VECTOR GRAPHIC INC.

HARDWARE BULLETIN NO. #80-1

VECTOR
TECHNICAL
ADVISORY

FLASHWRITER II Rev.3 APL MODIFICATION

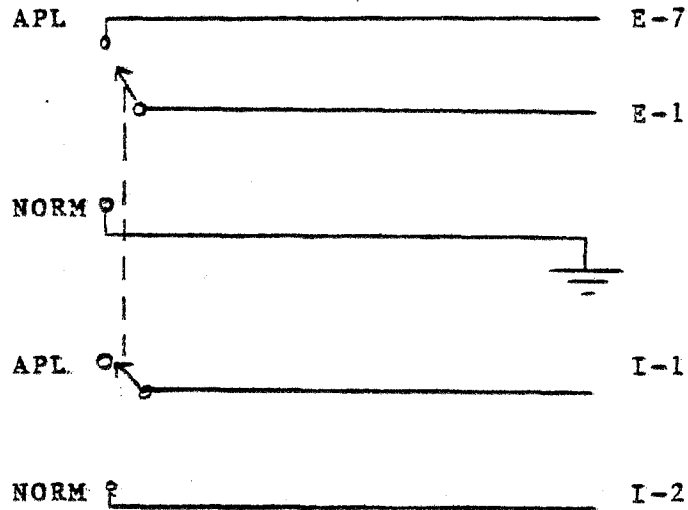
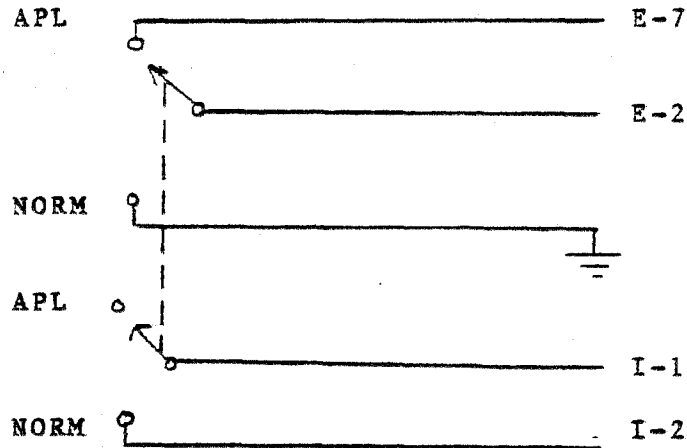
The attached pages explain the cuts and jumpers necessary to incorporate the APL Character Generator PROMs on the Flashwriter II Rev. 3.

Previous instructions sent with each order of APL were for Rev. 2 only.

I. For TMS 2716 proms only -

A) Add switch as shown below

B) Cut Etches	Jumper from
I1 to I2	B1 to B2
E1 to E4	E1 to E3
E2 to E5	E2 to E6
E3 to E9	E5 to U22-18
trace from U22-18

C) Insert APL PROMs at U22 and U23

Use APL TMS 2716 at U22
 Use APL 2708 at U23

II. For INTEL 2716 or TMS 2516 only -

A) Add switch as shown below

B) Cut etches.	Jumper from
I1-I2	B1-B3
E1-E4	E1-E5
E2-E5

C) Insert APL PROMs at U22 and U23

Use APL TMS 2516 or INTEL 2716 at U22
Use APL 2708 at U23

FIGURE 1
SEE P/L

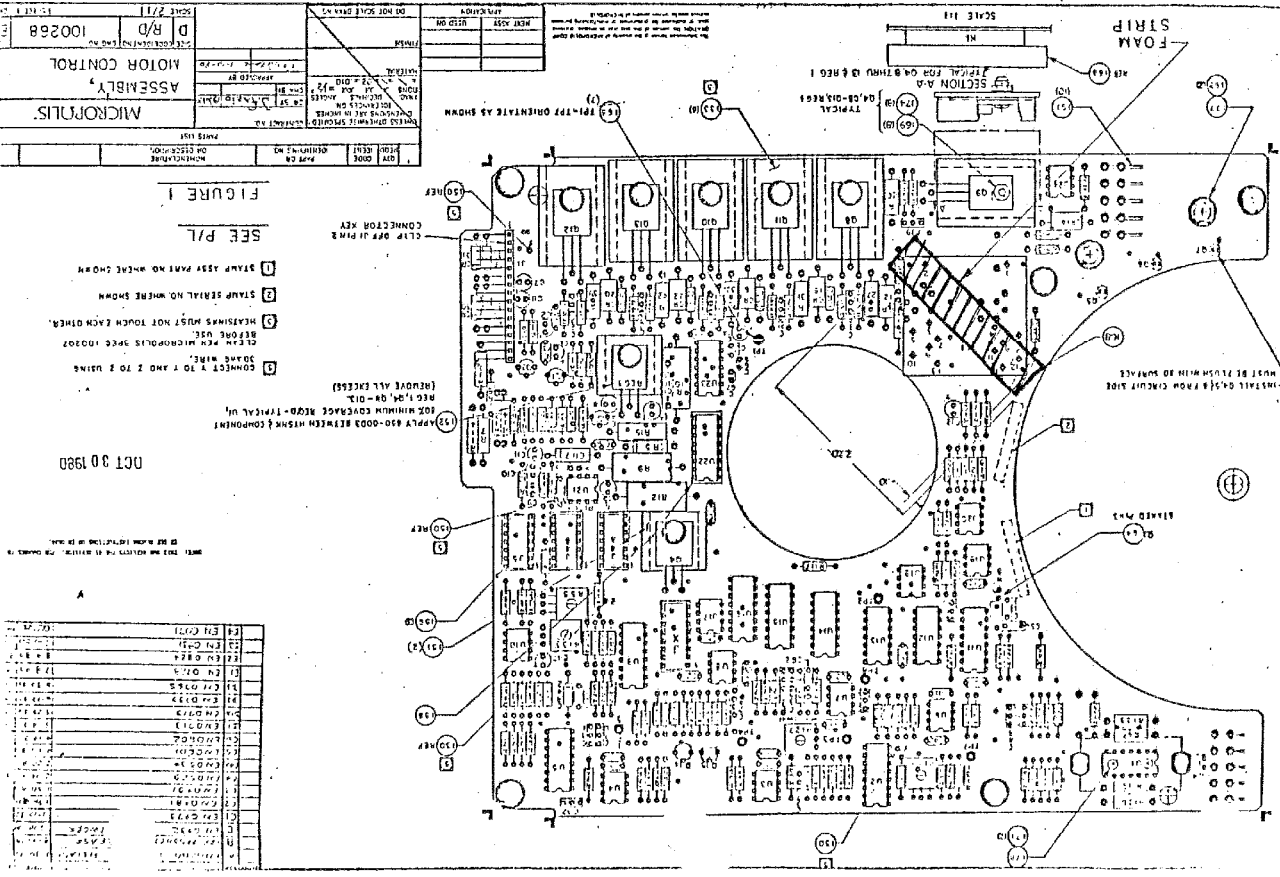
Description: Certain components on the motor control board and device electronics board were found to need additional air flow for proper cooling. This is accomplished by installing the foam tape as described in figures 1 and 2.

1. Loosen three large slot head screws securing the printed circuit boards (two screws near the edge connector, one near the center). Raise the hinged board assembly from the edge connector end.
2. Locate the large white relay adjacent to the D.C. drive motor on the motor control board. This board is directly attached to the drive. (see Figure 1).
3. Install the small 2" foam strip included onto the relay as illustrated in Figure 1 (Remove backing on tape to expose stick surface).*
4. Locate the large aluminum shield on the device electronics board. With the board stack swivled away from you, the device board will directly face you with the large shield covering a large portion of the left hand side of this board.

*Note: Rub tape firmly to push out air bubbles trapped under the tape.

V-3, VG-4G TRANSFORMER

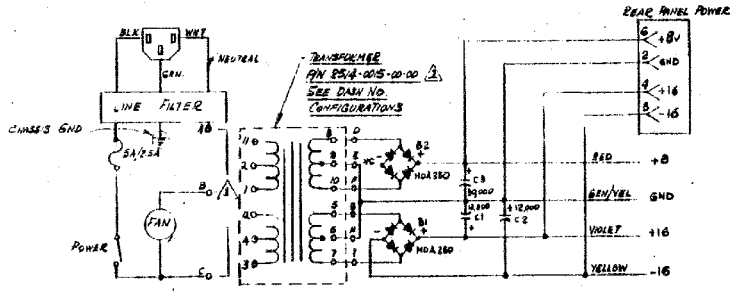
Vector has upgraded the Vector 3 from a VG-4 to a VG-4G. The VG-4G is slightly larger and has a higher rating. This was done to prevent the transformer from affecting the display in 220V. versions. Note that the connections are different than the VG-4.

SHEET 2/10
DATA BUS CONTROL

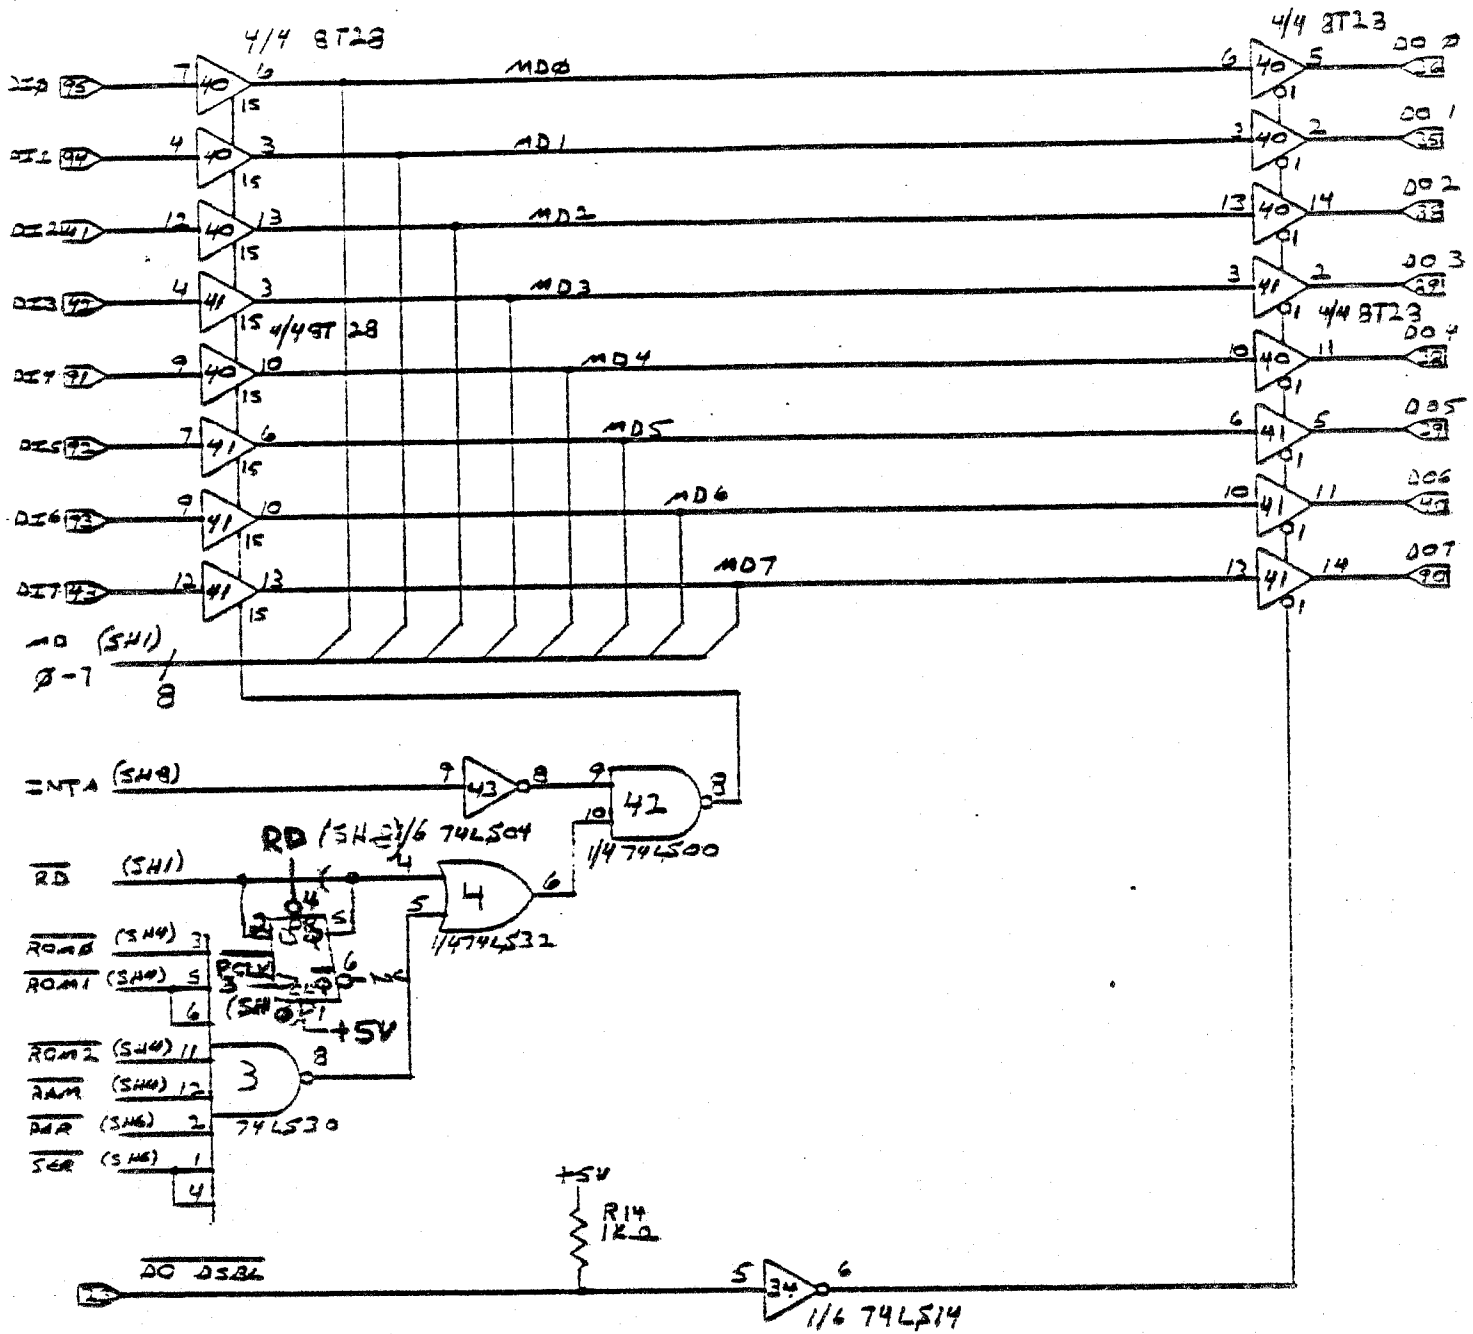
The Revision 3 ZCB board is now in production at Vector. This Revision was implemented in order to delay the RD signal, which was creating a race condition that caused a data glitch. This "glitch" could create memory errors that were attributed to the 64K PCB. This revision is a factory only modification. The error condition is apparent when a 64K PCB is swapped or the LS244's are changed to resolve a memory error, but the original 64K PCB functions properly with a different ZCB board. The attached schematic should be added to your ZCB documentation.

12" MONITOR KIT SCHEMATIC

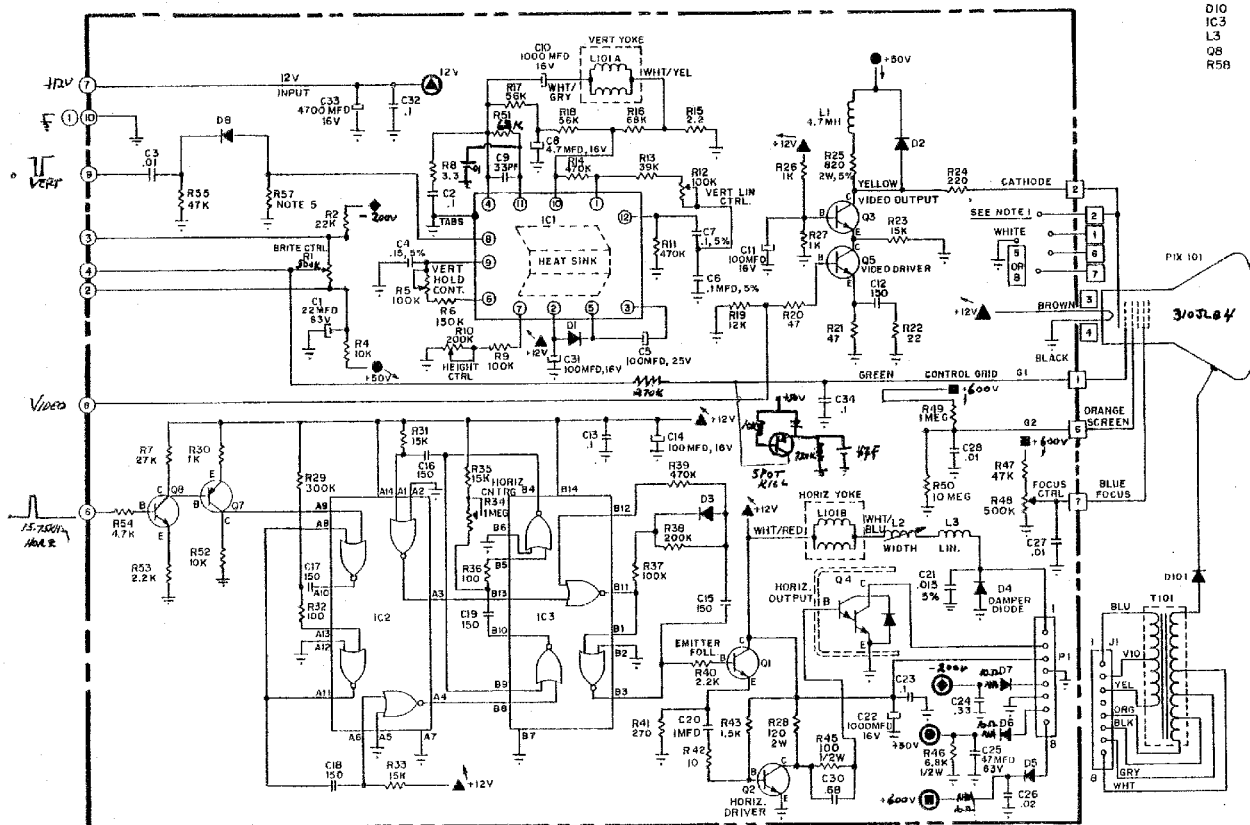
The Wells-Gardner CRT has been approved for use in Vector 3 systems. A schematic is provided for on page 2 of this VTA.
